Response to Technical Review Comments

Clear River Energy Center and Burrillville Interconnection Project

**Re: Clear River Energy Center, LLC
Burrillville RI
Application No. 17-0079**

Technical Review Comments of Documents Received by RI DEM on April 4, 2017

Exhibit 2
Abutters Maps

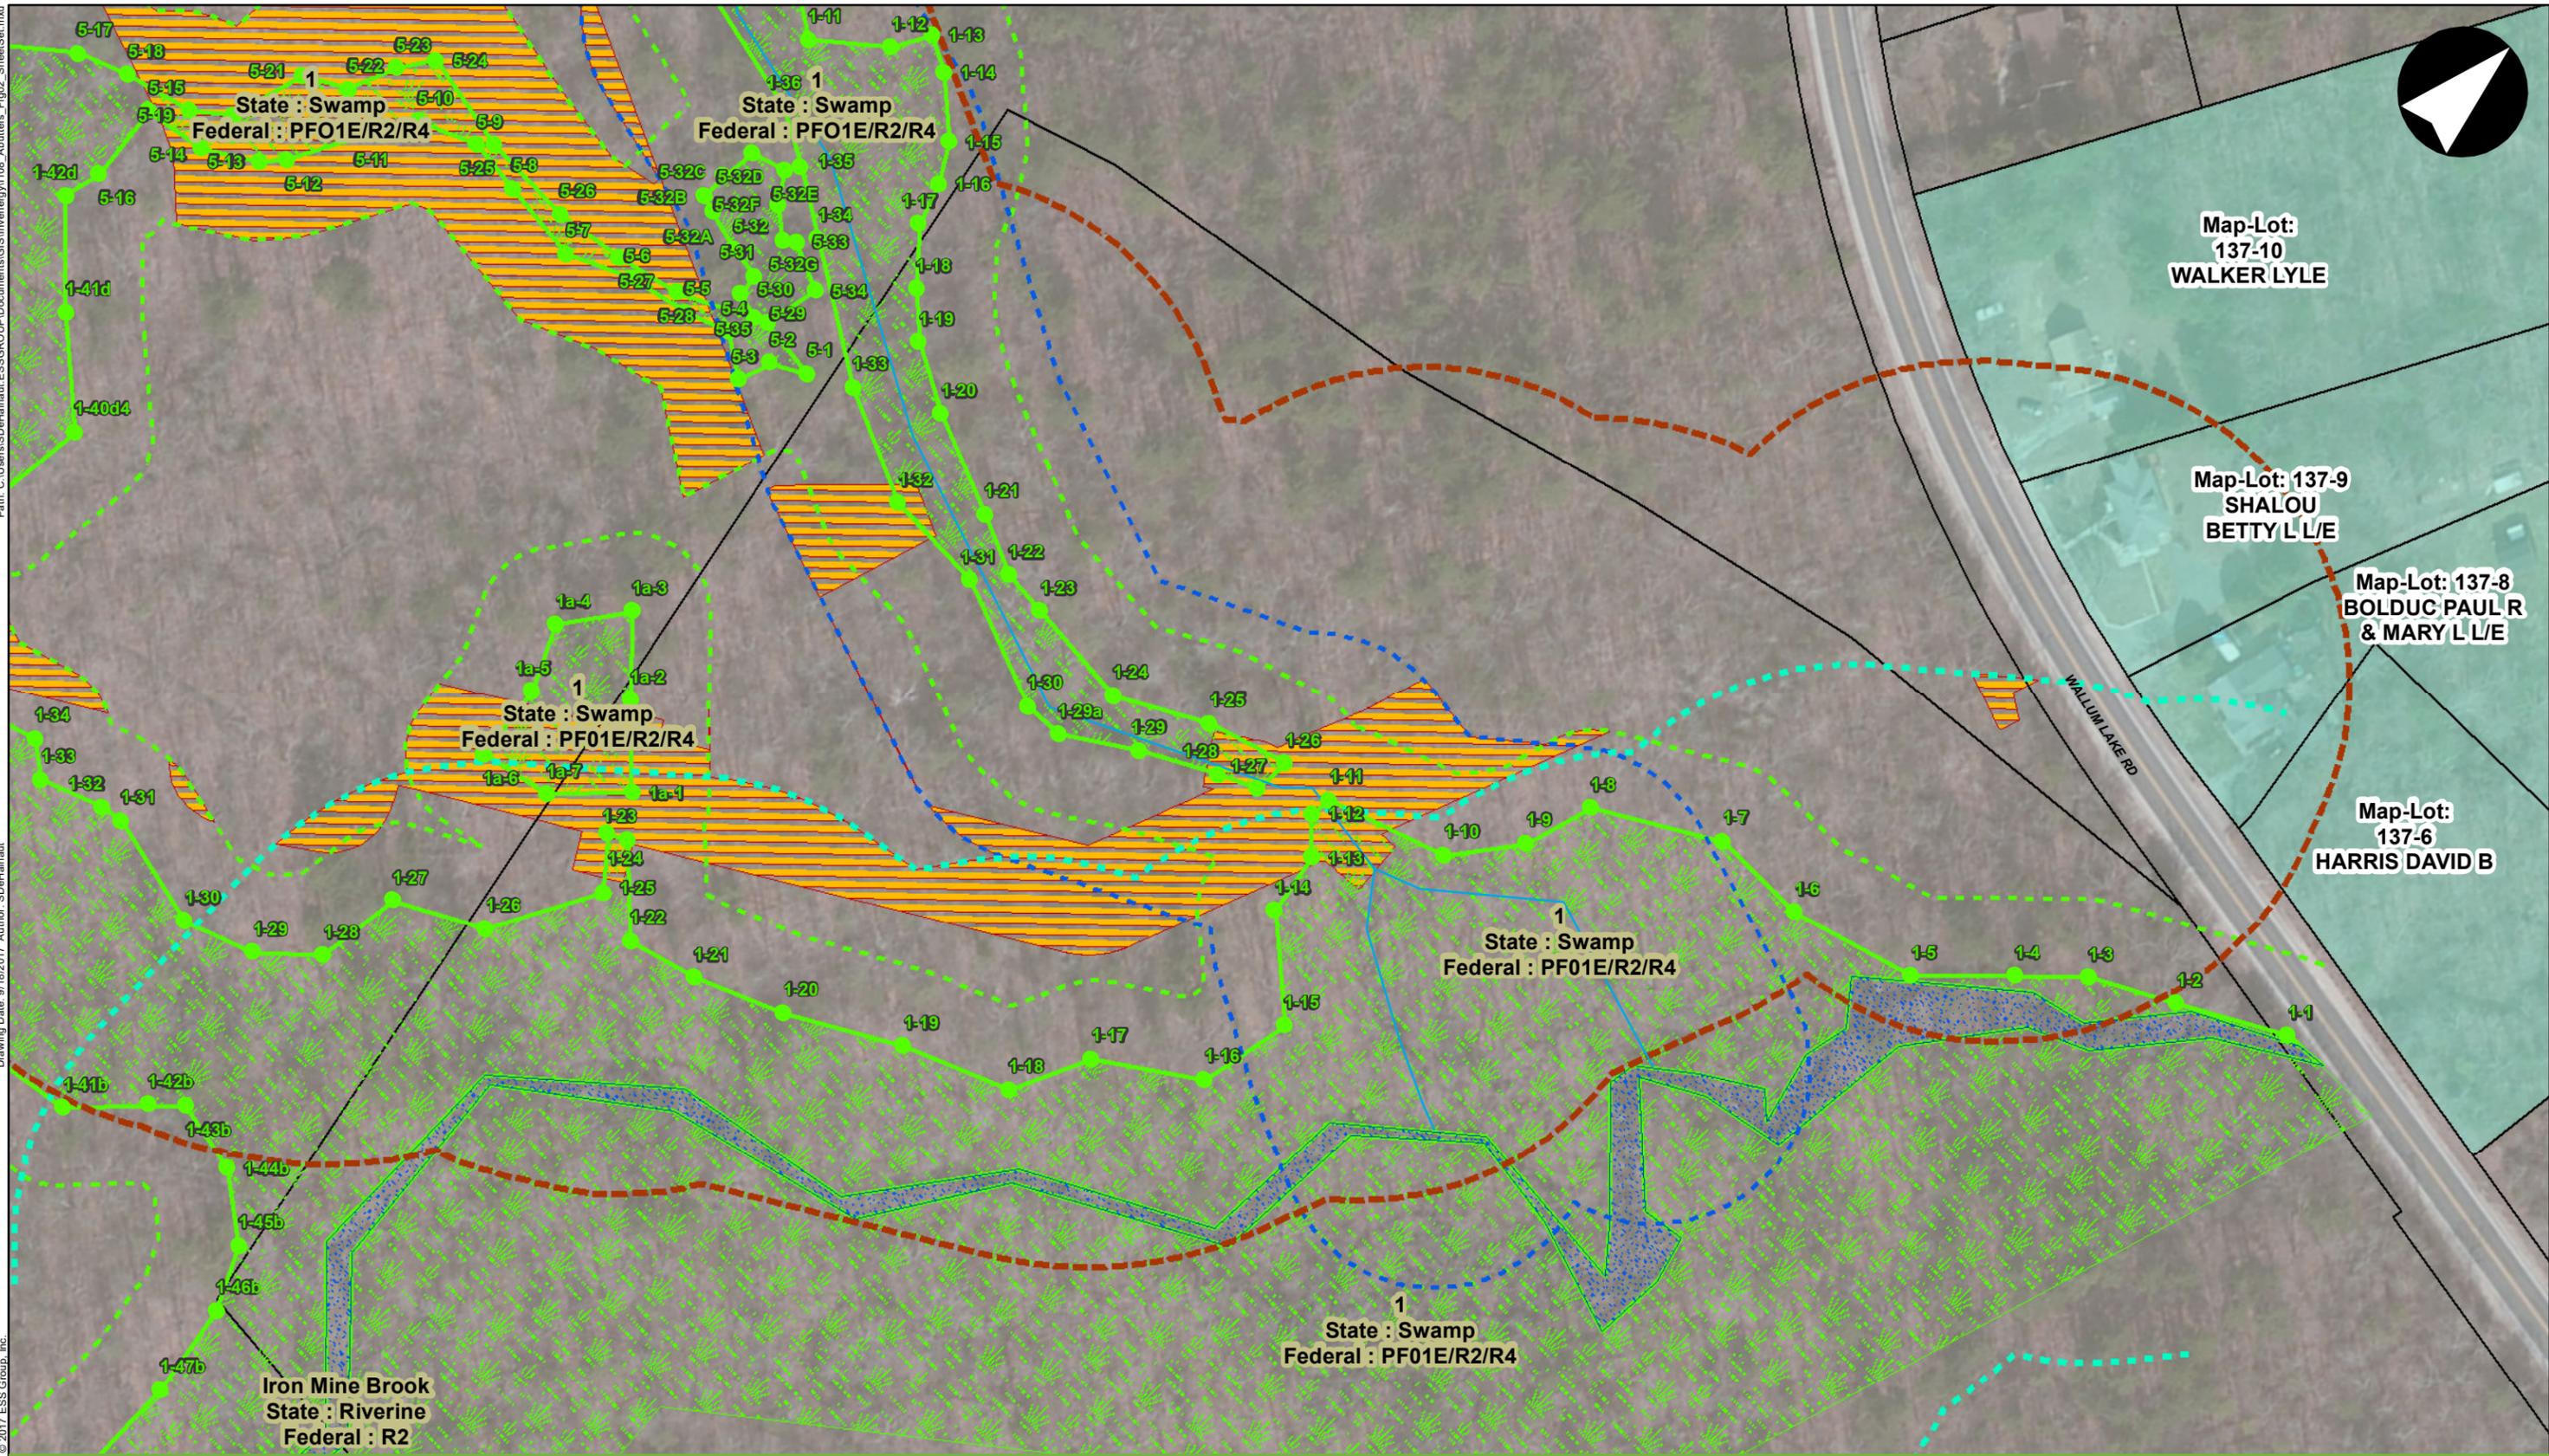
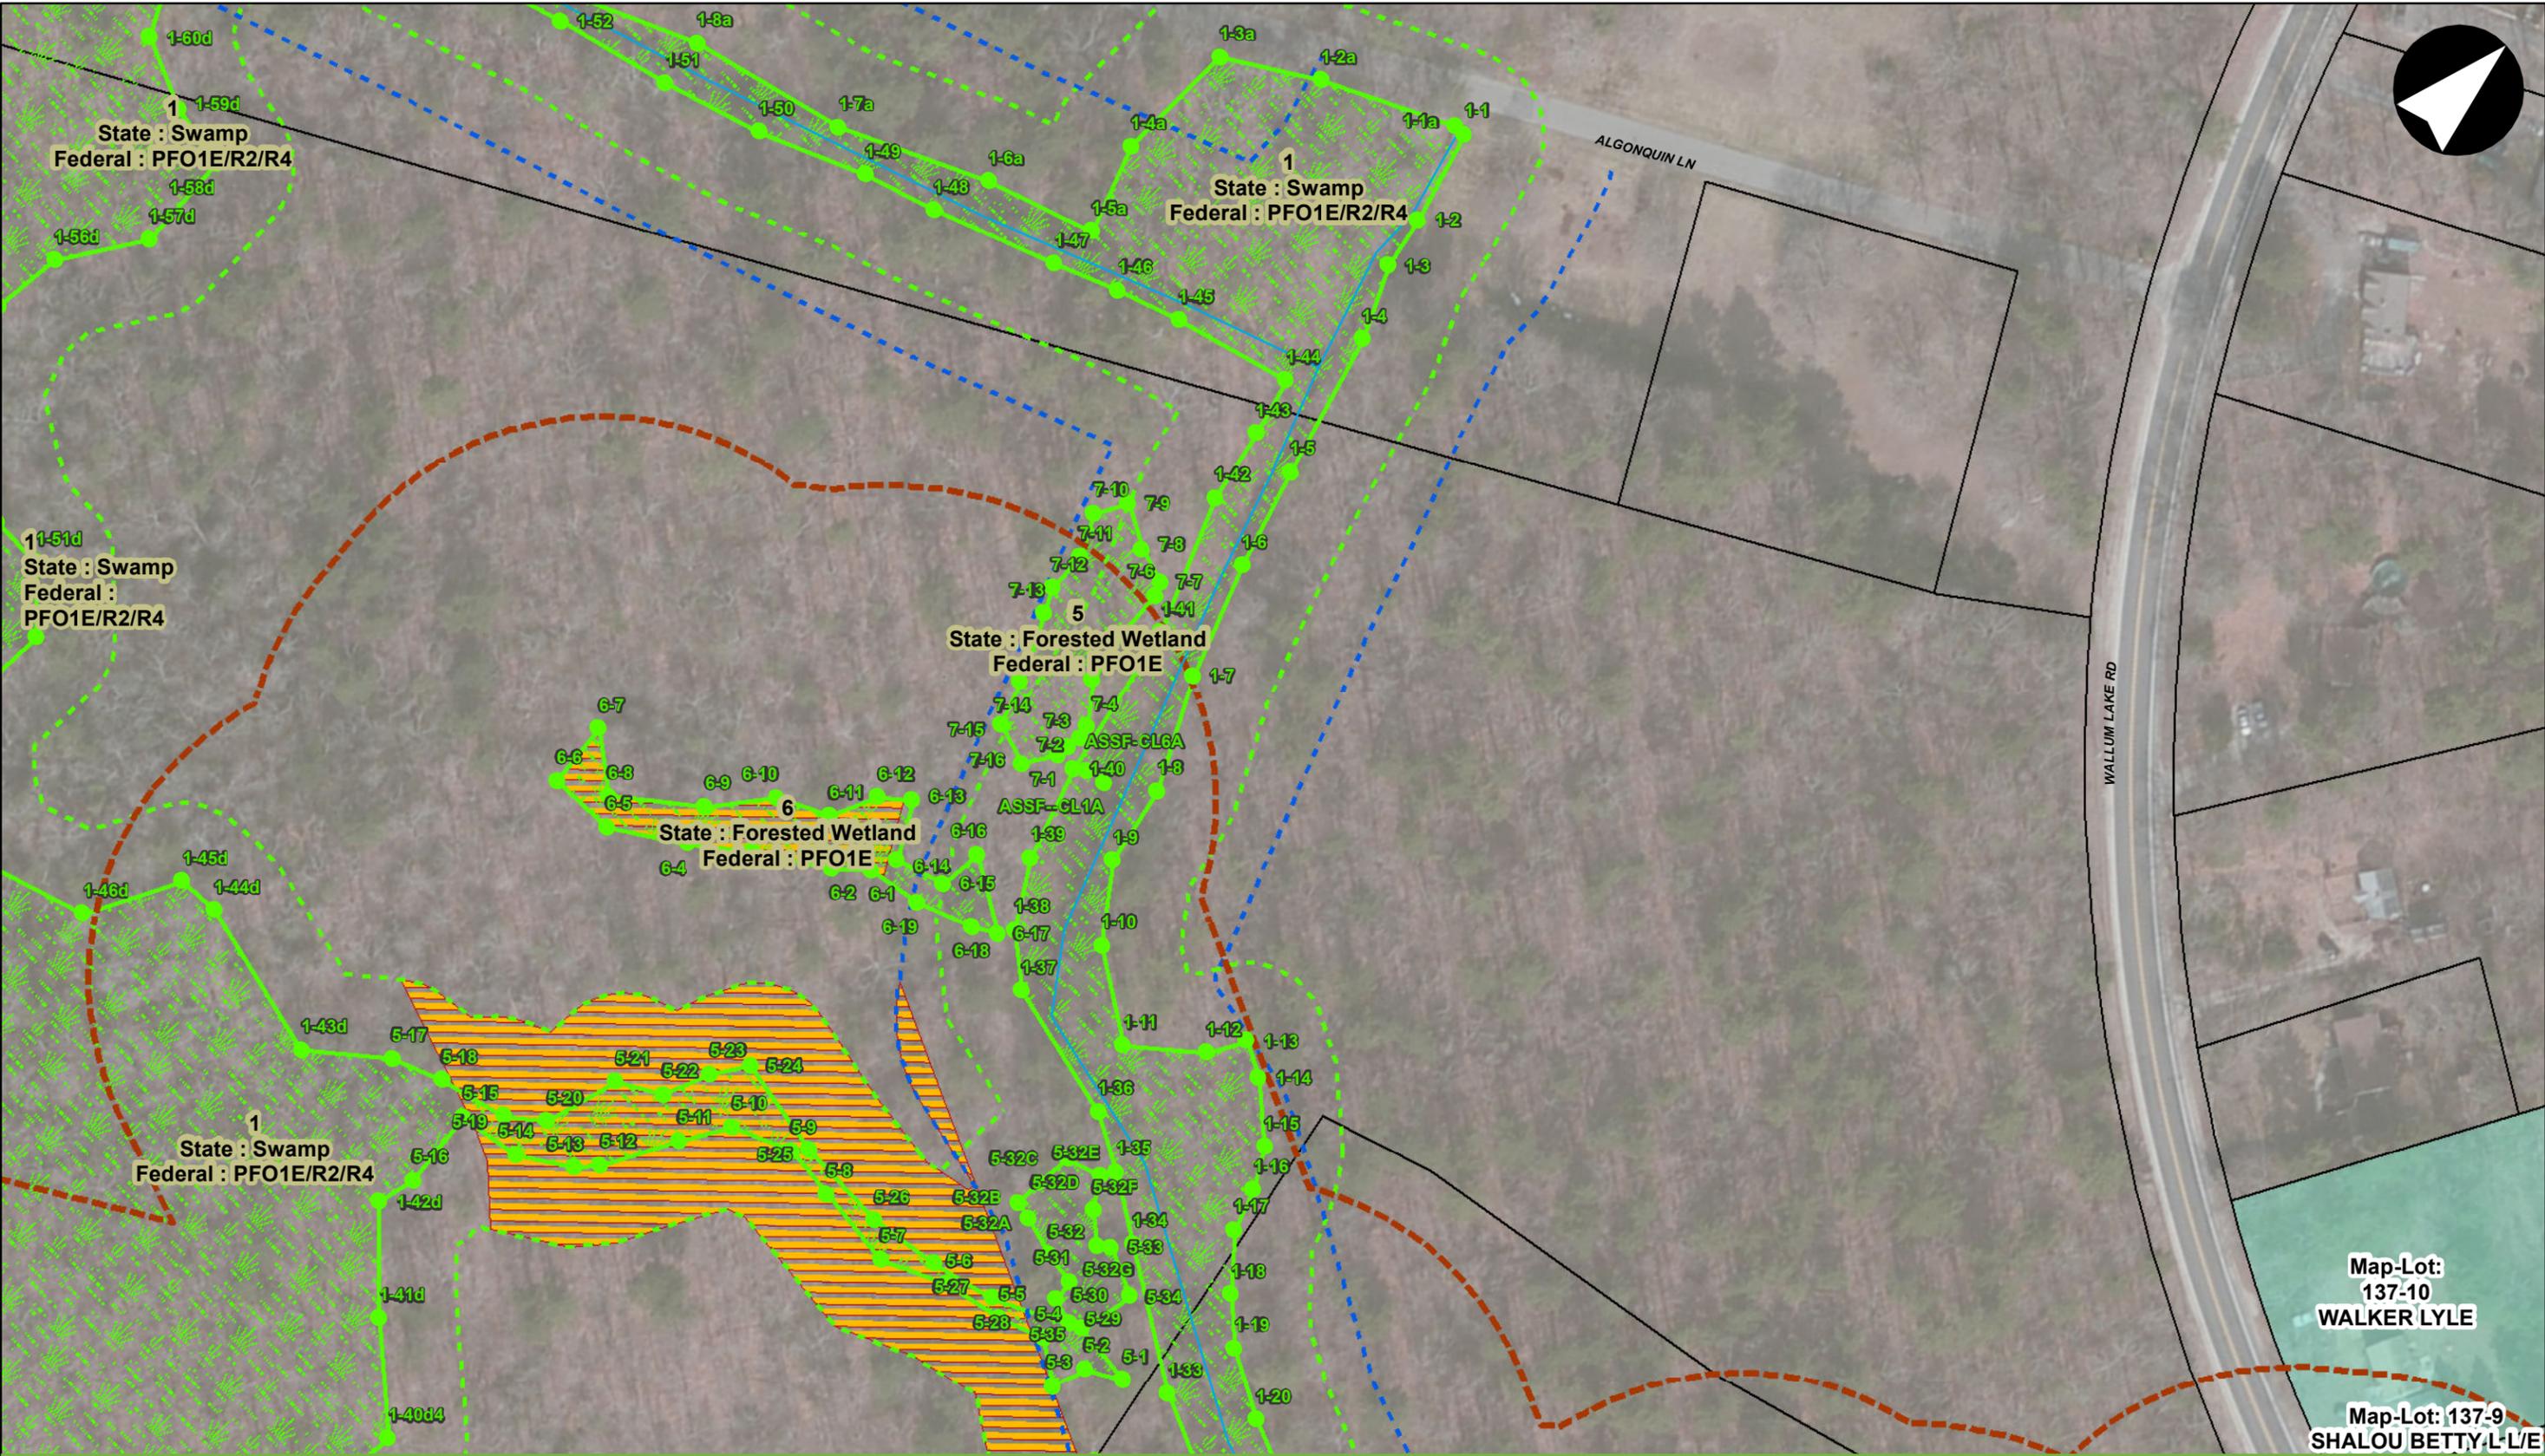
12. The Abutters Maps show project impact area, but the wetland is not identified on the various sheets. There is therefore no way to confirm if the maps are correct. Please clearly depict all wetland limits on the 200-foot radius maps and identify the wetlands similarly to how they are identified on the plan set.

Response: The abutters maps have been revised to depict all wetlands, and depicted wetlands have been labelled in a similar manner to the plan set (see Exhibit 2).
